UNITED STATES PATENT AND TRADEMARK OFFICE

10/516,447

Office Action Summary

BEN-HORIN, RAANAN

(marked Baker Figure 2)

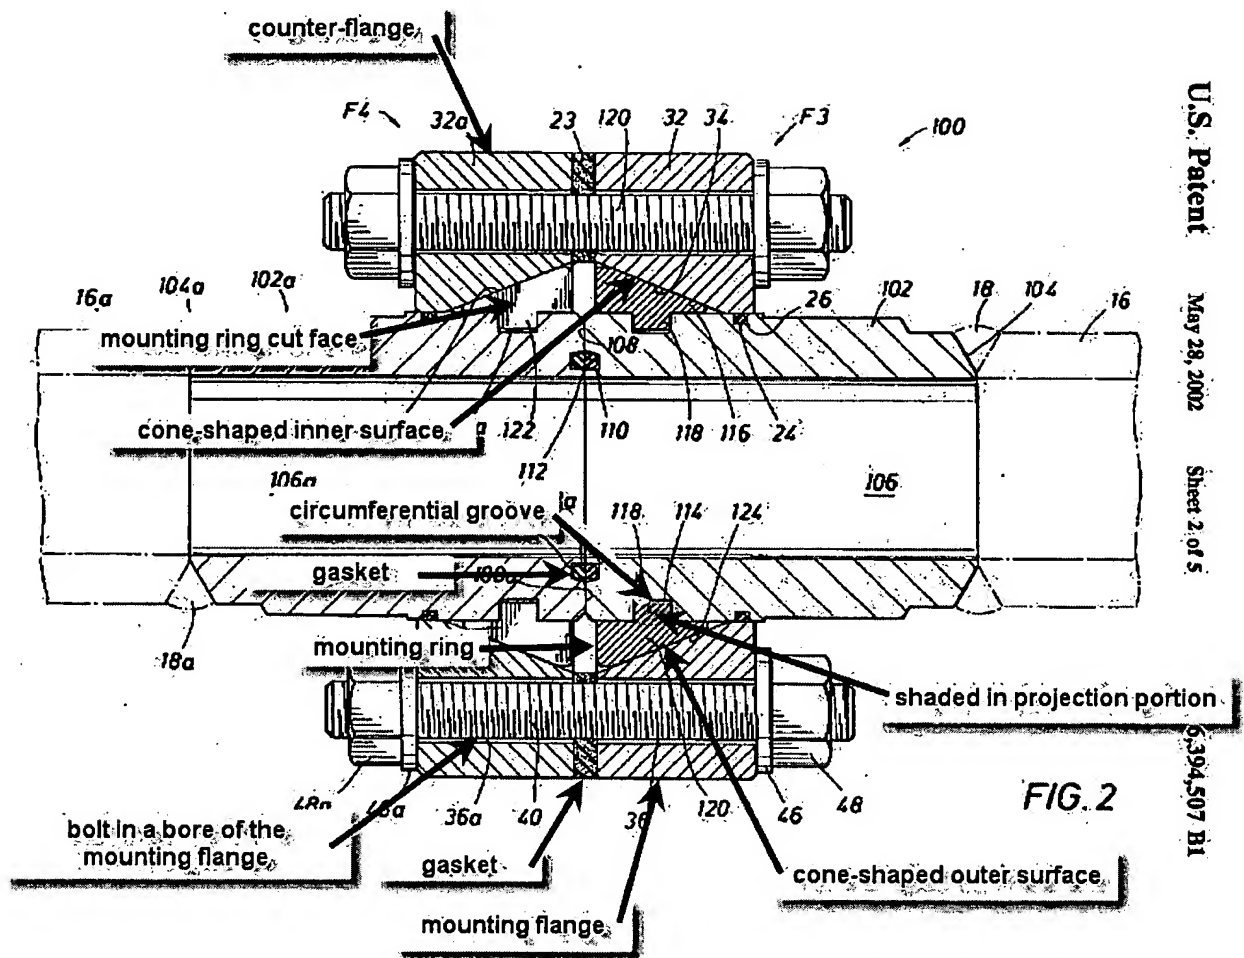
9. In regard to claim 21, Baker discloses in Figure 2, below, a pipe coupling for connecting a pipe (16) to a counter-flange associated with another pipe (16a) in a sealed manner, wherein the pipe is formed with a circumferential groove, the coupling comprising a gasket, a mounting ring, and a mounting flange, wherein the mounting ring has a cone-shaped outer surface (as observed in marked Figure 2 below and column 9, lines 29-31) and is elastically expandable (a material suitable for the mounting ring will have elastic properties) and grips around the groove by projection portions (shaded area as observed in marked Figure 2 below) fitting therein and holding the ring affixed to the pipe (column 9, lines 30-38) with the mounting flange having a cone-shaped inner surface (as observed in marked Figure 2 below and column 9, lines 39-43) and being tightened against the ring, the gasket and the counter-flange.

11. In regard to claim 23, Baker discloses that the ring is split by a cut extending in an axial plane thereof (as observed in marked Figure 2, above, the faces of the cuts, part 122, are in a plane with the sectional cut and therefore are made by a cut extending in an axial plane of the mounting ring).

15. In regard to claim 34, Baker discloses that the mounting flange is formed with an inner cone-shaped surface matching the cone-shaped surface of the ring (as observed in marked Figure 2 above).

16. In regard to claim 35, Baker discloses that the mounting flange is formed with a series of bores through which tightening bolts are adapted to pass (as observed in marked Figure 2 above).

mounting ring has a cone-shaped outer surface (as observed in marked Figure 2 above and column 9, lines 29-31) and is elastically expandable (a material suitable for the mounting ring will have elastic properties) and grips around the groove by projection portions (shaded area as observed in marked Figure 2 above) fitting therein and holding the ring affixed to the pipe (column 9, lines 30-38) with the mounting flange having a cone-shaped inner surface (as observed in

(marked Pfefferle Figure 6)

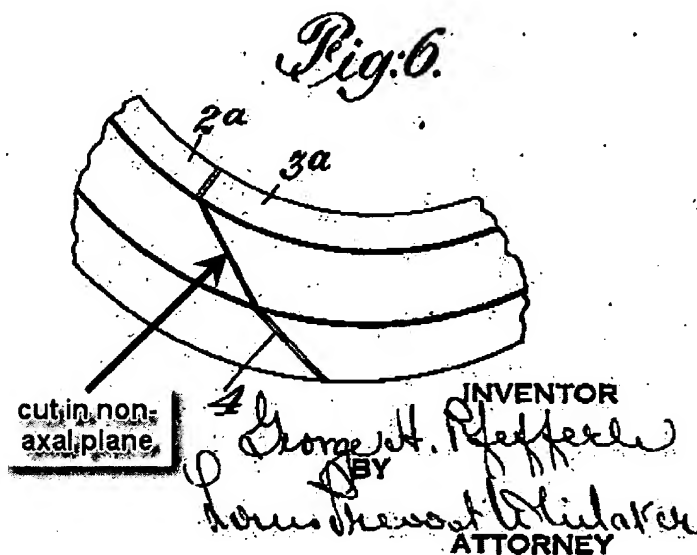
19. In regard to claim 24, Baker discloses the claimed invention except for the ring being split by a cut extending in a non-axial plane thereof. Pfefferle teaches a split ring, in Figure 6 below, used in pipe couplings that is split by a cut (4) extending in a non-axial plane to reduce

the tendency of the ring ends from separating when the ring is compressed (column 1, lines 22-33). As the cut ring of Pfefferle relates to joining the ends of split rings, it would have been obvious to one having ordinary skill in the art at the time the invention was made to split the ring of Baker with a cut extending in a non-axial plane as taught by Pfefferle to reduce the tendency of the ring ends from separating when the ring is compressed.

(marked Martin Figure 3)

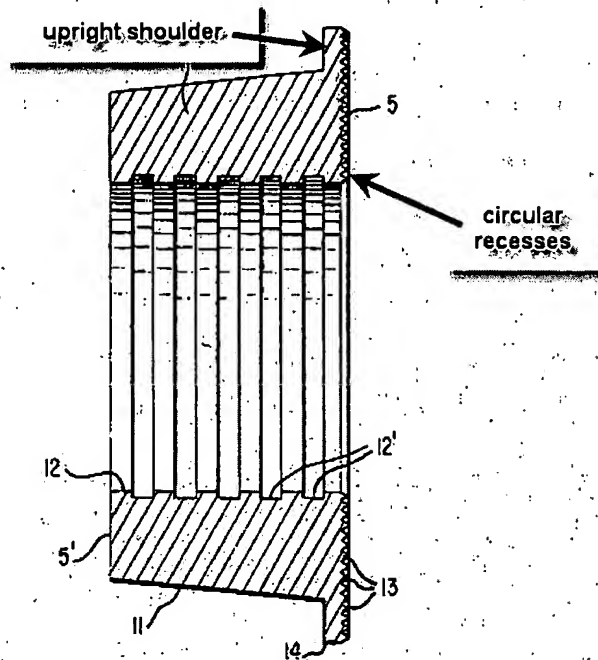
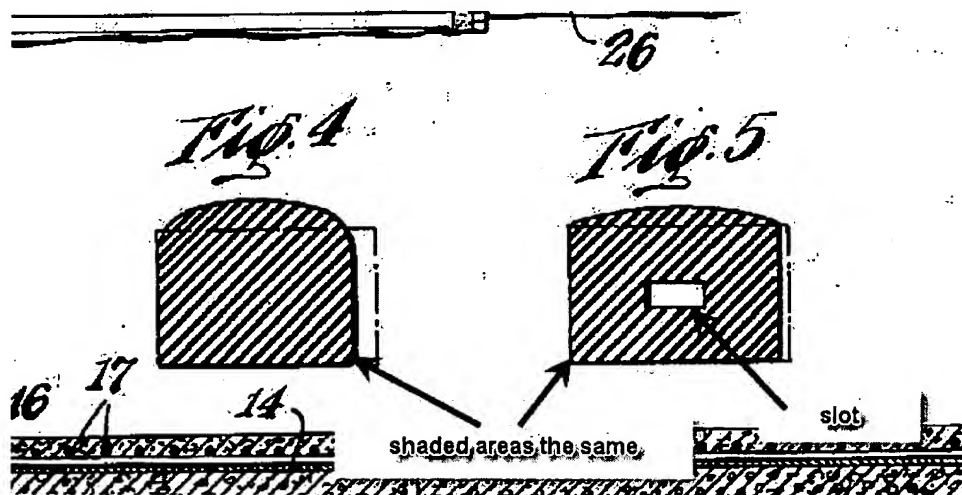
25. In regard to claim 28, Baker discloses the claimed invention except for the mounting ring having a circular recess for the gasket. Martin teaches a pipe coupling with a mounting ring, as observed in marked Figure 3 below, with circular recesses (13) to engage a gasket and improve sealing (column 2, lines 40-44). It would have been obvious to one having ordinary skill in the

26. In regard to claim 33, Baker discloses the claimed invention except for an upright shoulder extending around the end of the cone-shaped surface. Martin, in marked Figure 3 above, further teaches a mounting ring with an upright shoulder (14) to prevent the ring from being pulled through the mounting flange (column 2, lines 62-66). It would have been obvious to one having ordinary skill in the art at the time the invention was made to modify the mounting ring of Baker with an upright shoulder as taught by Martin to prevent the mounting ring from being pulled through the mounting flange.

(marked Trickey Figures 4 and 5)

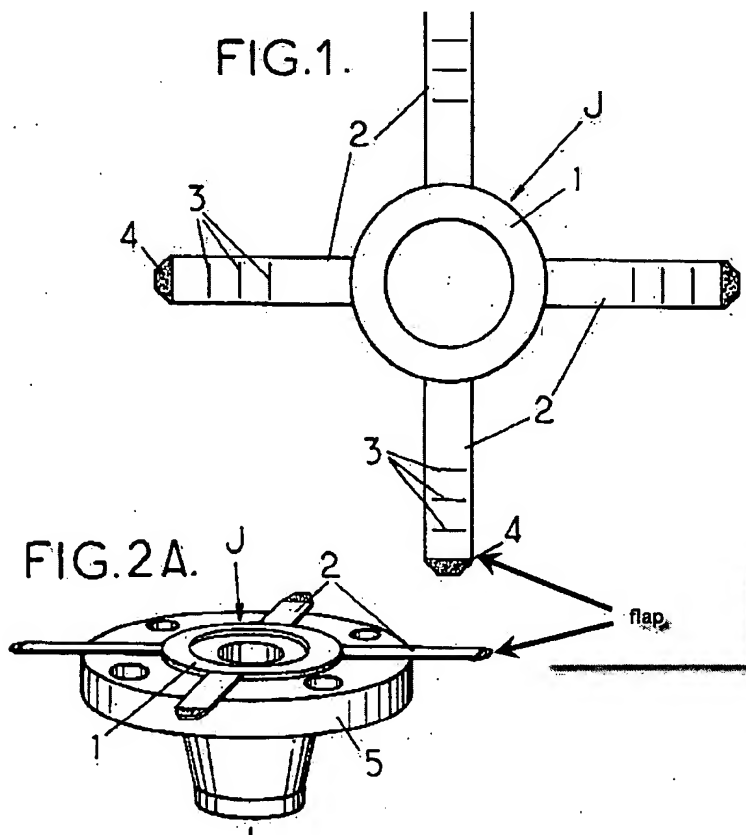
28. In regard to claim 29, Baker in view of Martin provide the claimed invention except for the gasket having an inner slot. Trickey teaches in Figure 5, below, a pipe joint gasket having an inner slot to allow a larger gasket perimeter for a given volume of gasket material (column 4, line 146, through column 5, line 13). As Trickey relates to gaskets, it would have been obvious to one having ordinary skill in the art at the time the invention was made to form the gasket of Baker with an inner slot as taught by Trickey to allow a larger gasket perimeter for a given volume of material.

(Milot et al Figure 1)

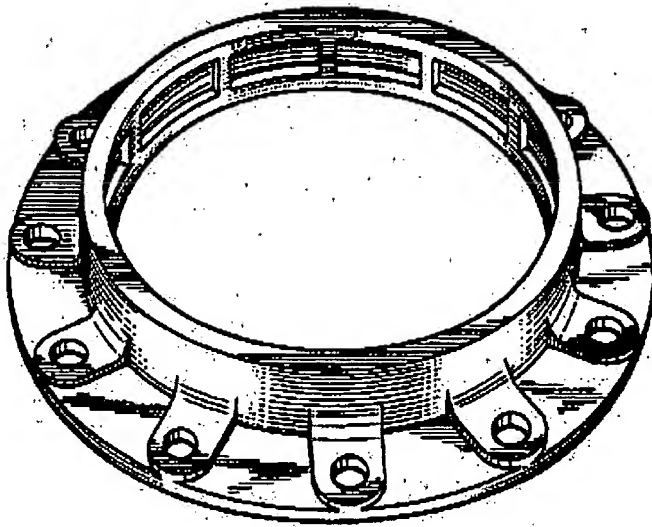
32. In regard to claim 36, Baker discloses the claimed invention except for the series of bores being partly surrounded by arcuate projections. Milot et al teach a flange in Figure 1, below, with arcuate projections partly surrounding the bores to buttress the flange against tensional bending when the bolts are tightened. As relates to flanges, it would have been obvious to one having ordinary skill in the art at the time the invention was made to provide the flange of Baker with arcuate projections partly surrounding the bores as taught by Milot et al to buttress the flange against tensional bending when the bolts are tightened.

(marked Risley Figures 27 and 29)

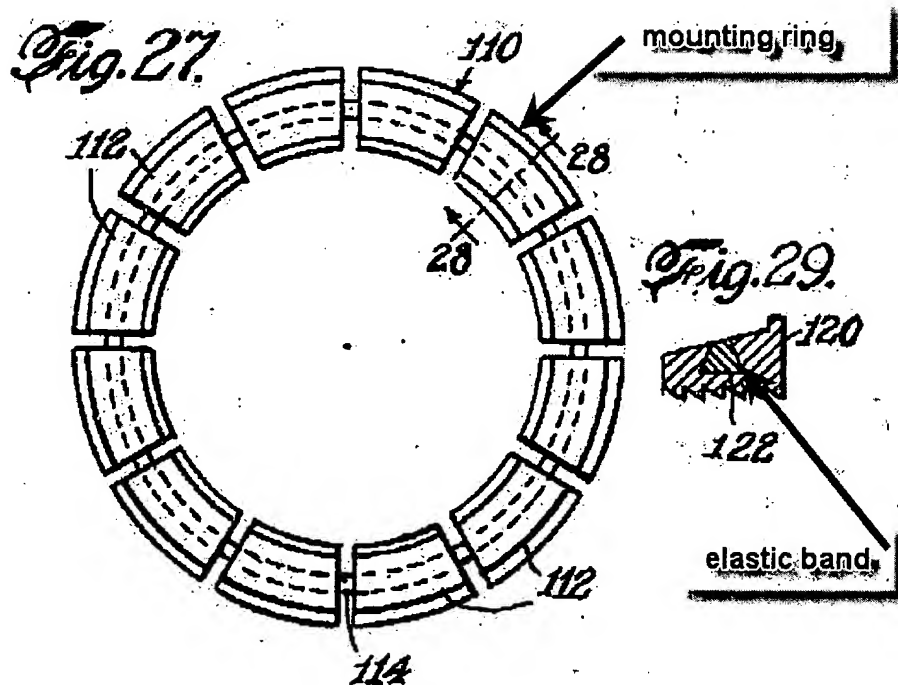
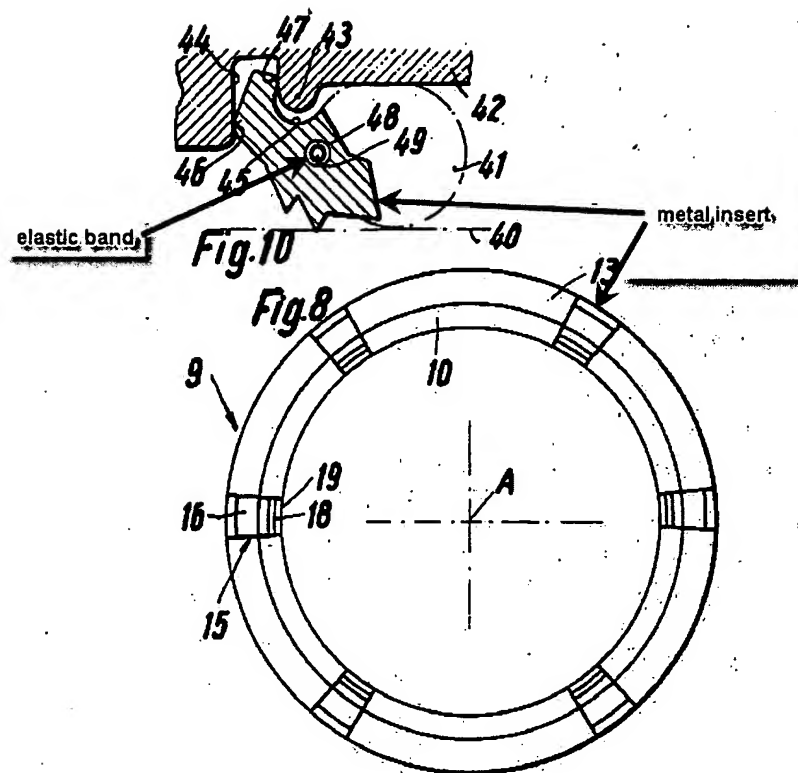
34. In regard to claim 37, Baker discloses the claimed invention except for the ring segments being held together by an elastic band. Risley teaches a pipe coupling with a multi-segment mounting ring in Figure 27, below, with an elastic band (122 as observed in Figure 29, below) holding the segments together to allow the segments to be moved radially inwardly into engagement with the pipe surface when compressed (column 6, lines 33-40). As relates to multi-segment mounting rings, it would have been obvious to one having ordinary skill in the art at the time the invention was made to fabricate the mounting ring of Baker with an elastic band as taught by Risley to allow the segments to be moved radially inwardly into engagement with the pipe surface when compressed.

(marked Seiler Figures 8 and 10)

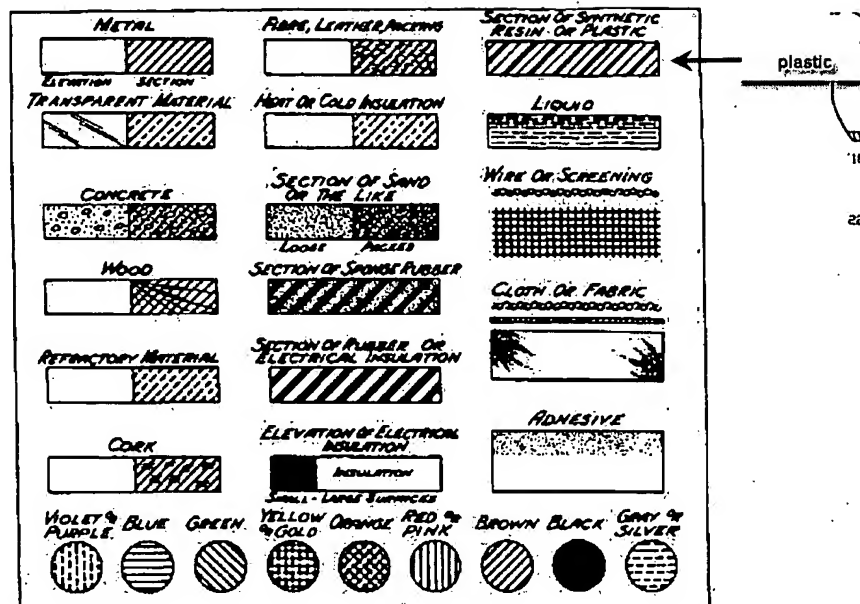
36. In regard to claim 38, Baker in view of Risley provide for the claimed invention except for metal inserts being interposed between adjacent segments. Seiler in Figures 8 and 10, below, teach placing metal insets (metal as shown by the crosshatching in Figure 8) as an anti-thrust provision in rings of pipe connections to secure the male end against thrust (column 1, lines 1-2, and column 1, line 68, through column 2, line 1). As relates to pipe connection rings, it would have been obvious to one having ordinary skill in the art at the time the invention was made to provide the segmented ring as provided by Baker in view of Risley with metal inserts interposed between adjacent segments as taught by Seiler to secure the male end against thrust.

37. In regard to claim 39, Seiler further teaches that the segments and inserts be held together by an elastic band threaded therethrough to secure the metal segments in the ring (column 6, lines 12-26). As relates to pipe connection rings, it would have been obvious to one having ordinary skill in the art at the time the invention was made to hold the segments and inserts of the segmented ring provided by Baker in view of Risley by an elastic band threaded therethrough as taught by Seiler to secure the metal segments in the segmented ring.
